**Town of Kittery  
 Planning Board Meeting  
 April 11, 2019**

**ITEM 2 - Huntington Run Cluster Subdivision – Major Modification to an Approved Subdivision Plan**

**RE: Town of Kittery, Planning Board Services  
Huntington Run Cluster Subdivision; 40 Betty Welch Road, Tax Map 66, Lots 2A, 8, & 8A  
Review #3. CMA #591.108**

## EXHIBIT- A

**LOT PLAN - A AMENDMENT**

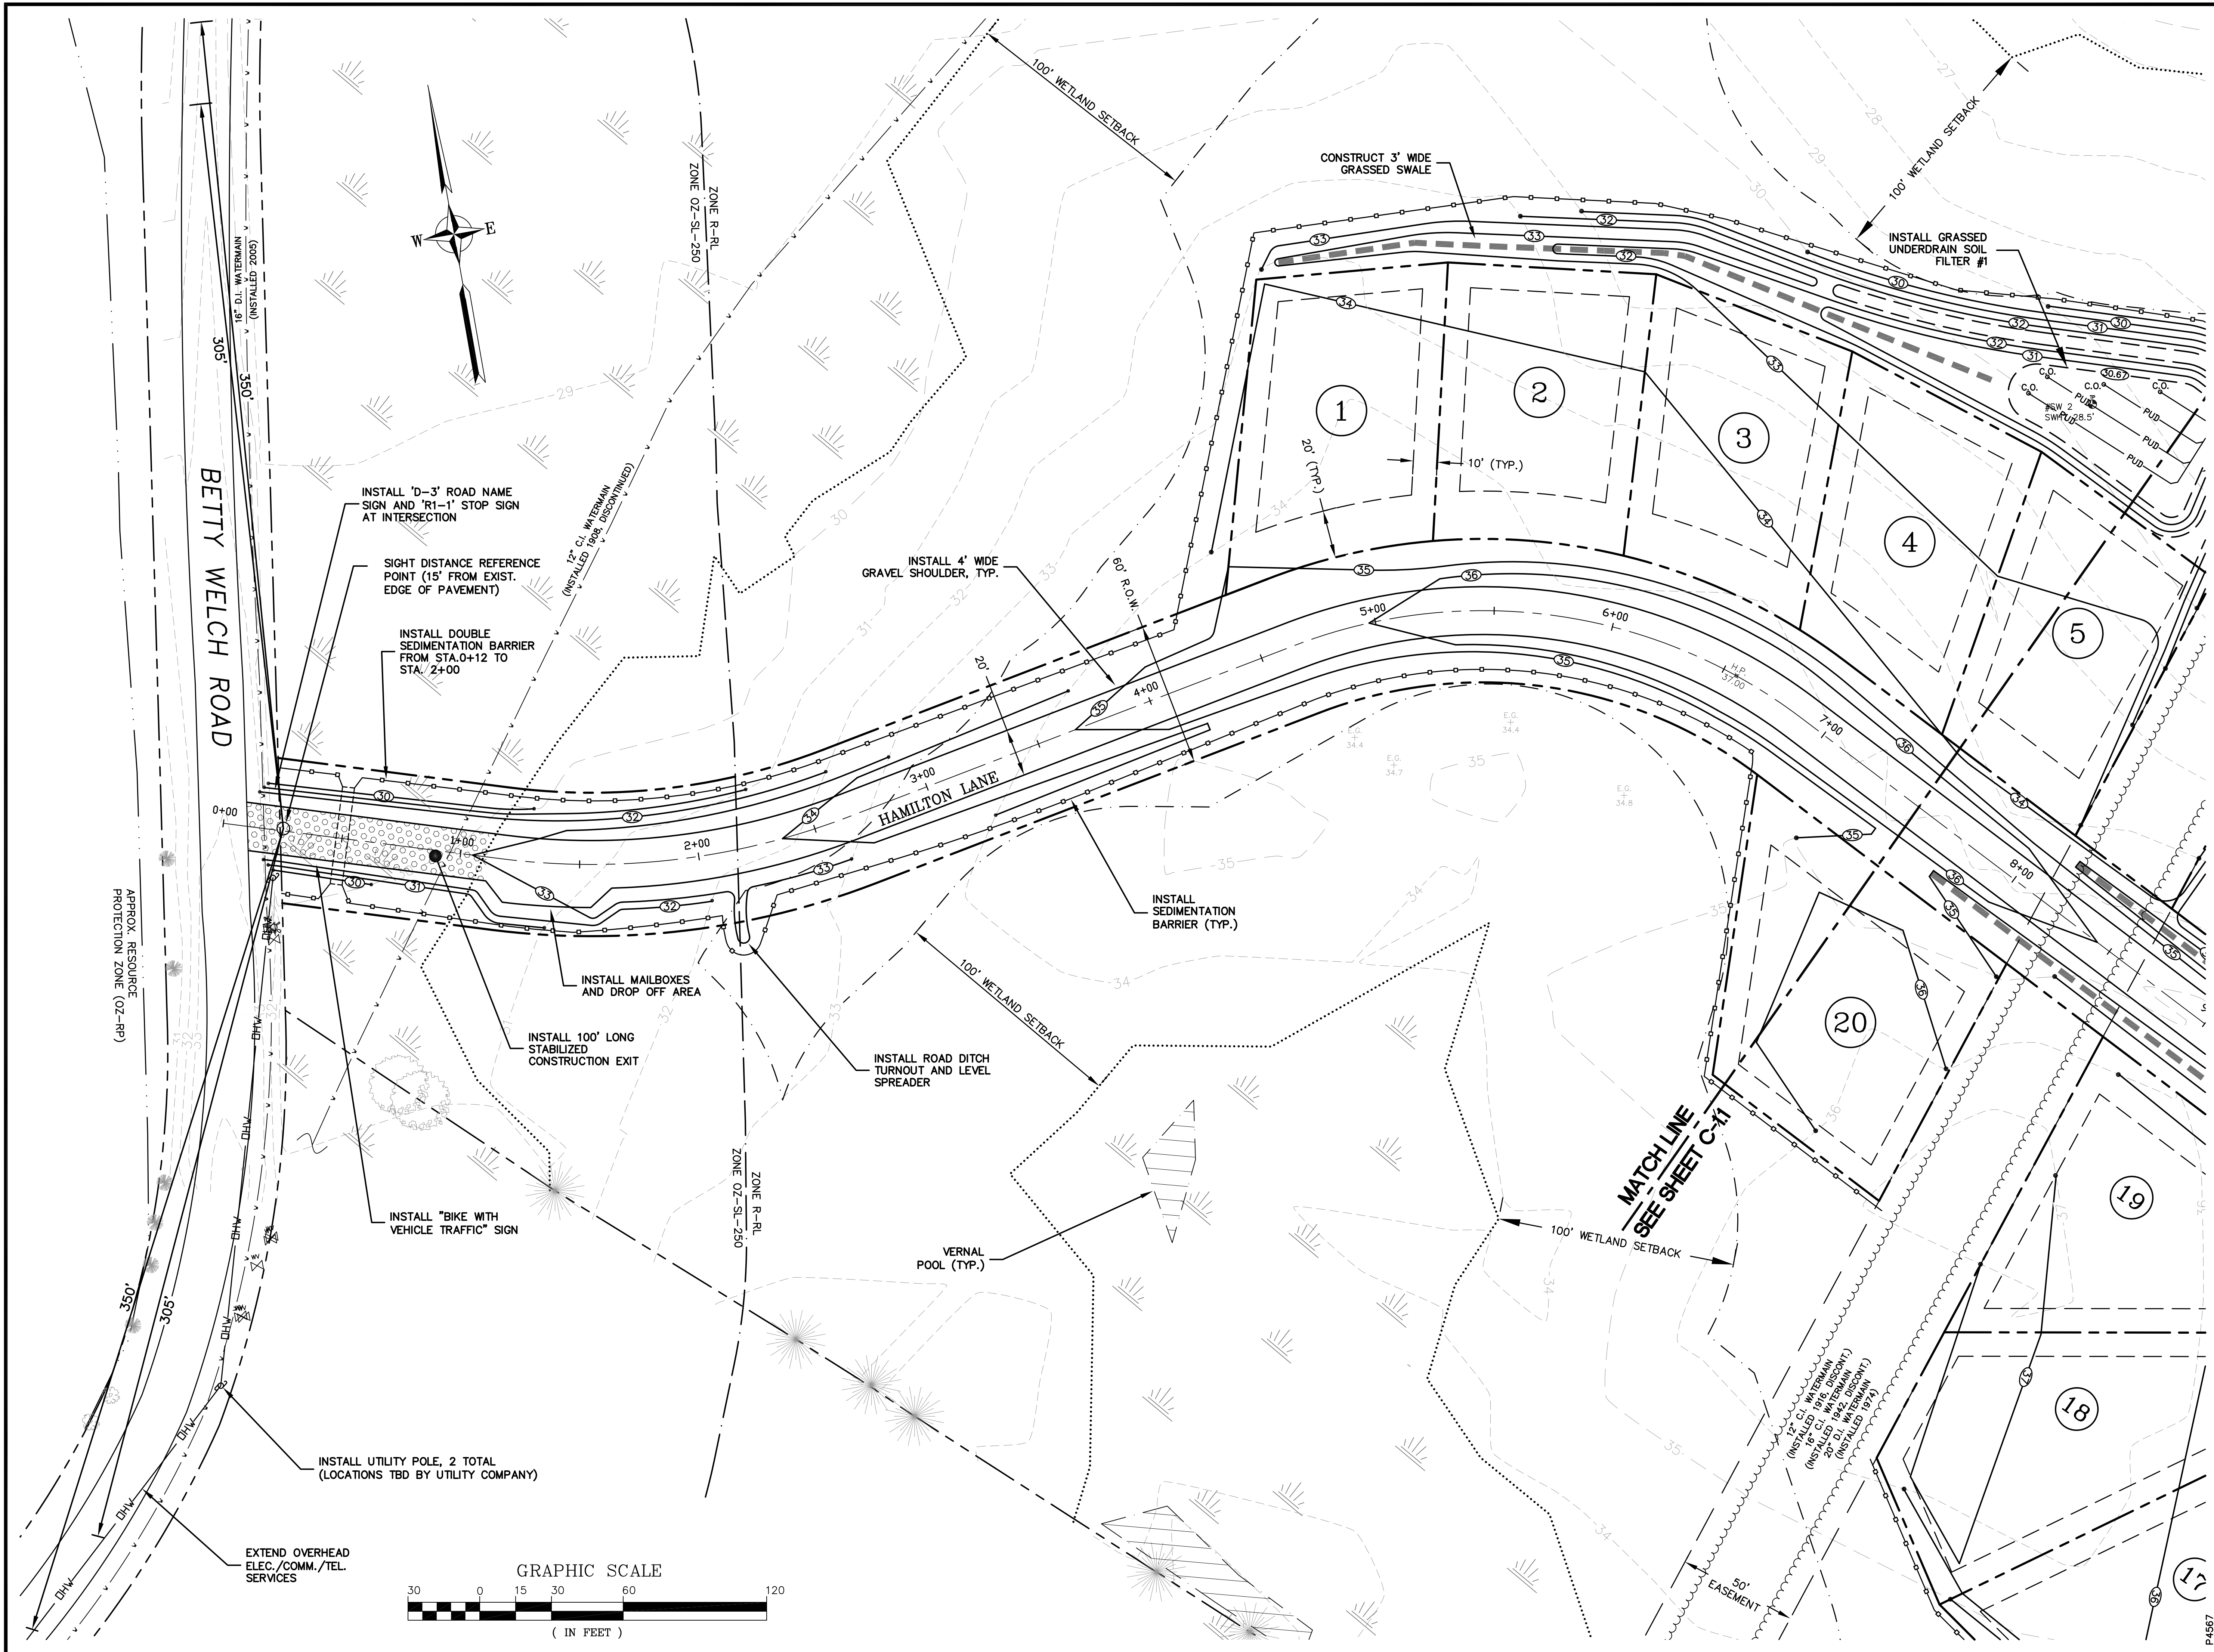
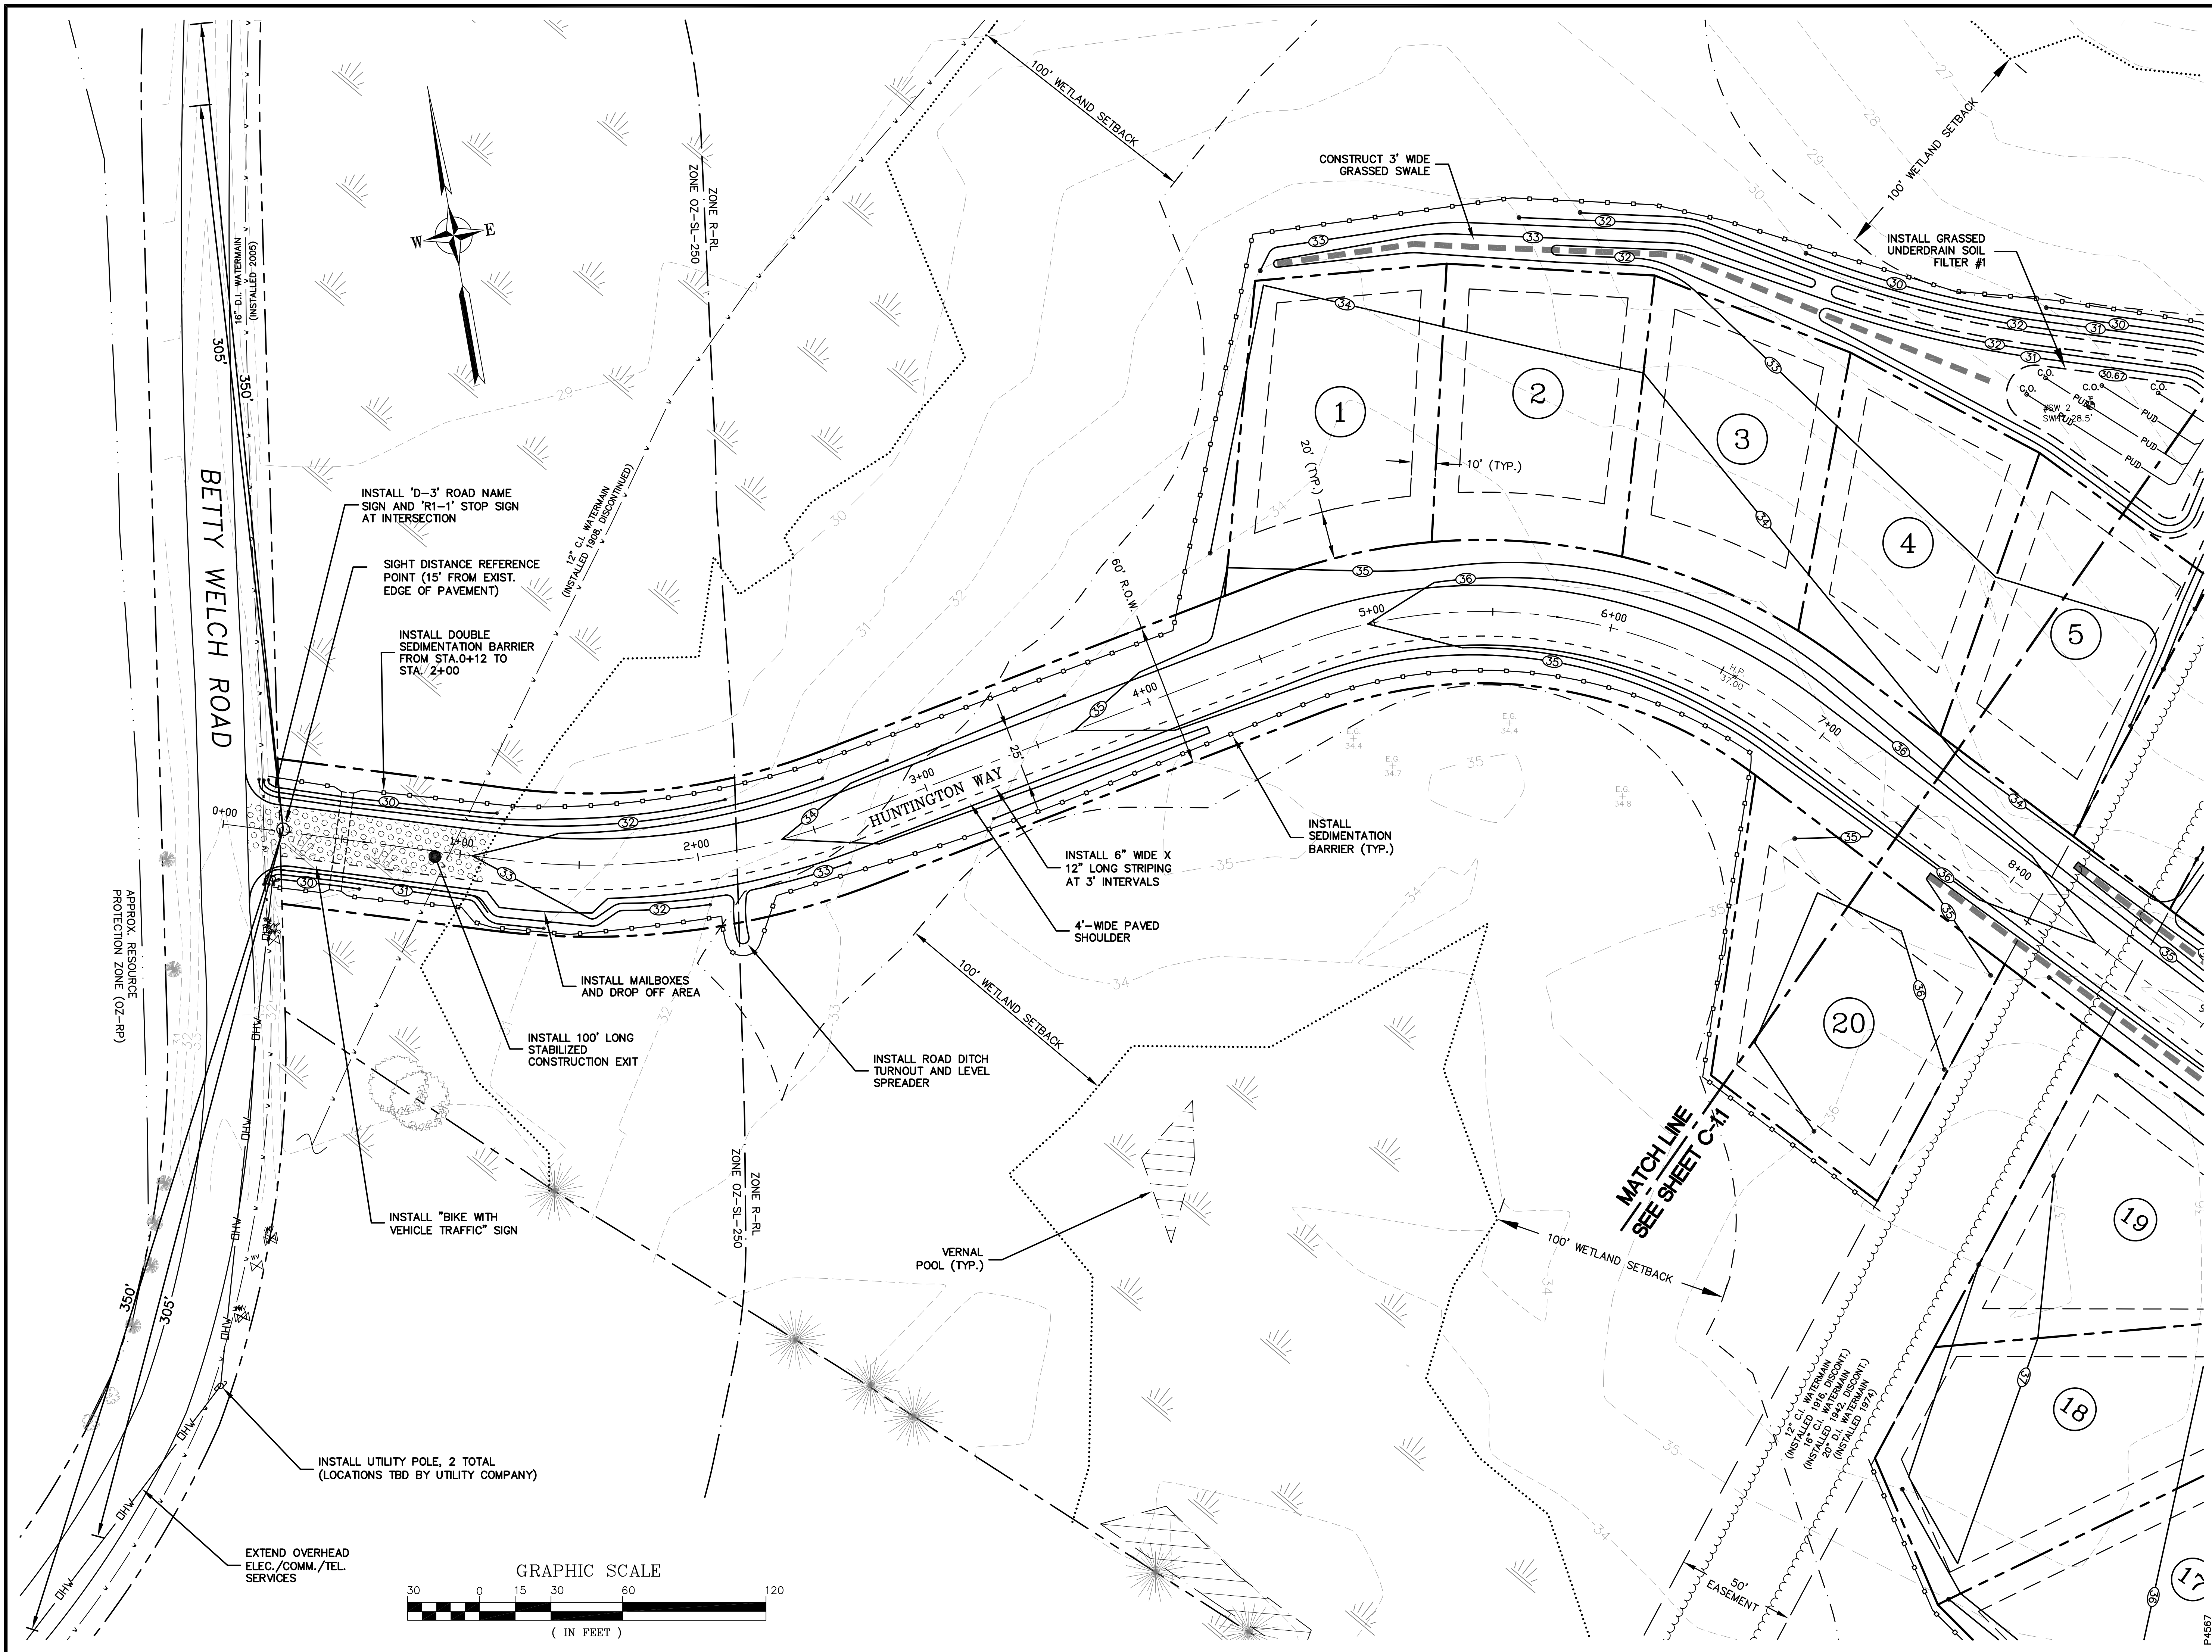
Here are the roadway plans that have the hydrant locations. There is the existing one on Betty Welch Road at the entrance and the new one in the cul-de-sac loop. They are not changing with this modification.

The Kittery Planning Board voted to approve the final plan for the Huntington Run Cluster Subdivision project at their March 14, 2019 meeting. On behalf of the applicant and owner, Chinburg Development, LLC, we respectfully submit the enclosed *Major Modification to an Approved Site Plan Application* to amend the approved plan by providing a 4 foot wide paved shoulder on the south side of Huntington Way from its intersection with Betty Welch Road to the beginning of the cul-de-sac loop (adjacent to Lot 19). All other roadway shoulders are proposed as 1 foot of pavement with gravel shoulders of varying width as depicted on the plans. The proposal requires a waiver from Section 16.8.4.4 and Table 1 Private Streets Standard – Street Width Design d. Paved Shoulder.

NO.	DESCRIPTION	BY	DATE
0	PB SUBMISSION	JKC	6/22/17
1	MDEP SUBMISSION	JKC	3/19/18
2	REVISED ROADWAY WIDTH	JKC	8/23/18
3	TOWN FINAL APPROVAL	JKC	1/24/19
4	ADD WALKWAY	JKC	3/21/19
